Project:
The Artistry at Walker's Point

BID PACKAGE #2

Sheet:
Building Elevations

Sheet No.:
A4.1 proposed

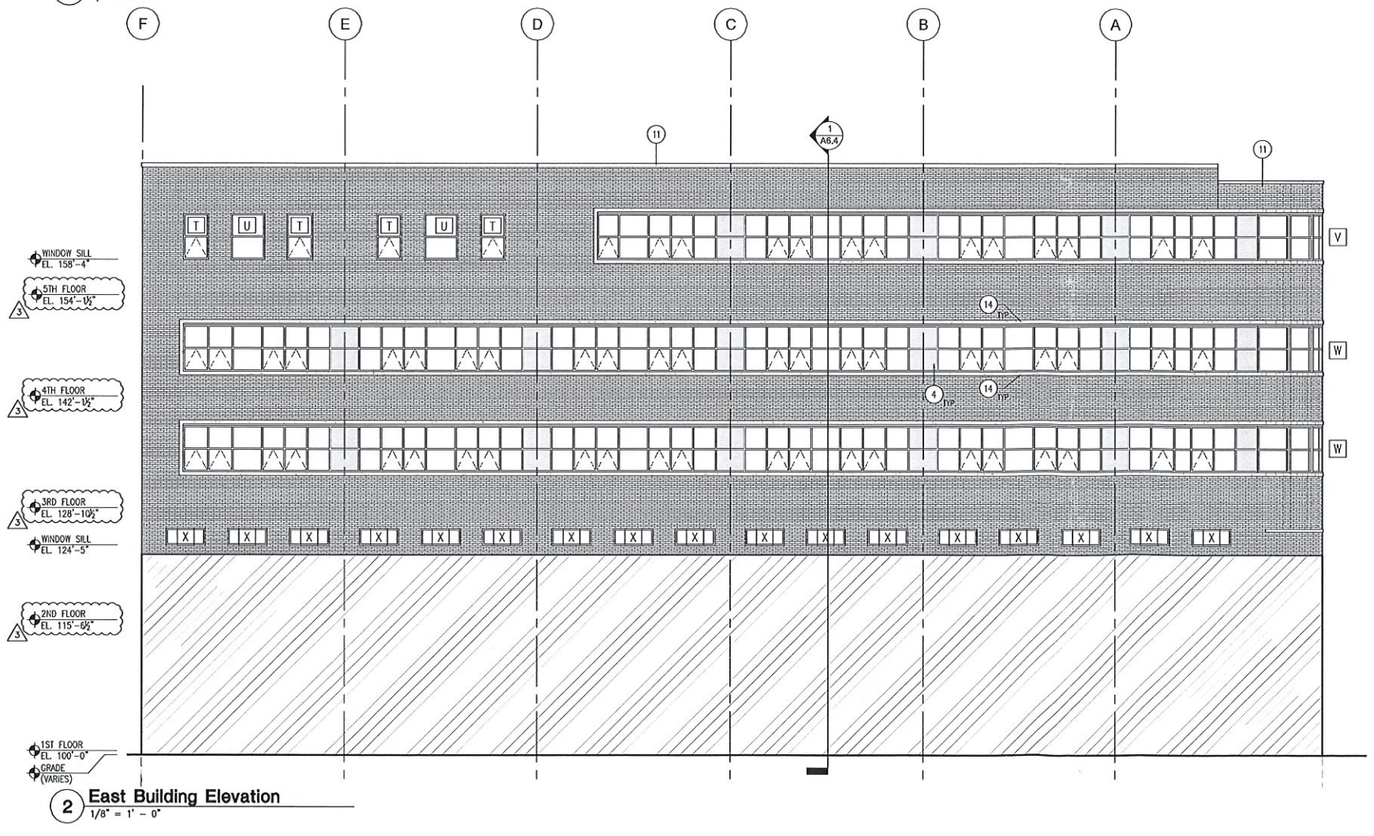
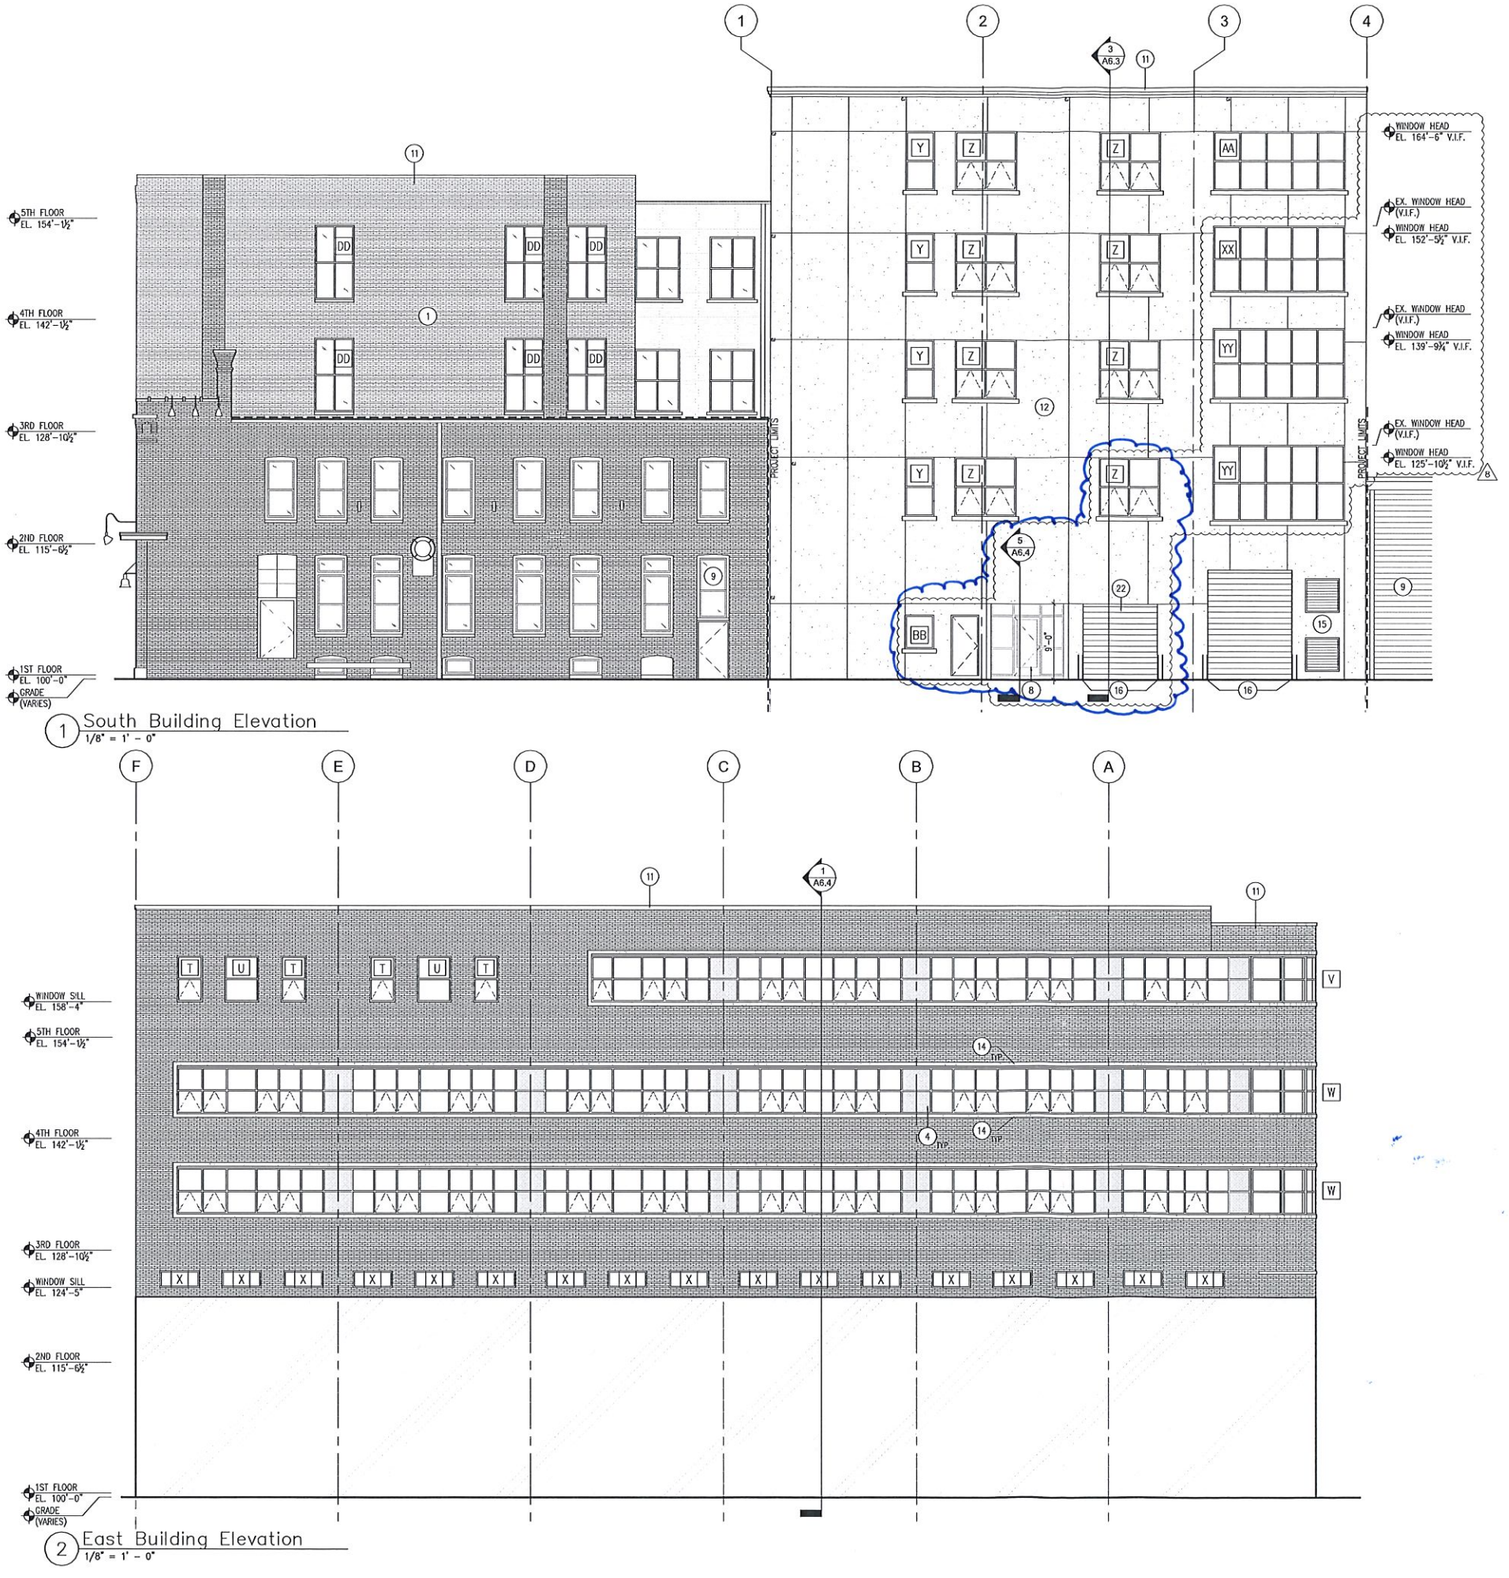
17. NEW MASONRY INFILL TO MATCH EXISTING.
18. NEW PRECAST CONCRETE SILL.
19. EXTEND EXISTING PARAPET WALL EAST TO FACE OF ADJACENT WALL. TOOTH IN MASONRY TO ADJOINING WAL TIE IN FLASHING, COPING, AND ROOFING MEMBRANE AS NECESSARY TO PROVIDE A WATER-TIGHT ASSEMBLY.

20. NEW 2'-7½" x 11'-6½" MECH. LOUVER (V.I.F.). SEE MECH. DRAWINGS.
21. NEW 42" x 50" MECH. LOUVER 36" MIN. ABOVE ADJACENT ROOF. SEE MECH. DRAWINGS.
22. NEW 8000# VEHICLE ELEVATOR WITH SINGLE SECTION GATE. REFER TO FLOOR PLAN.
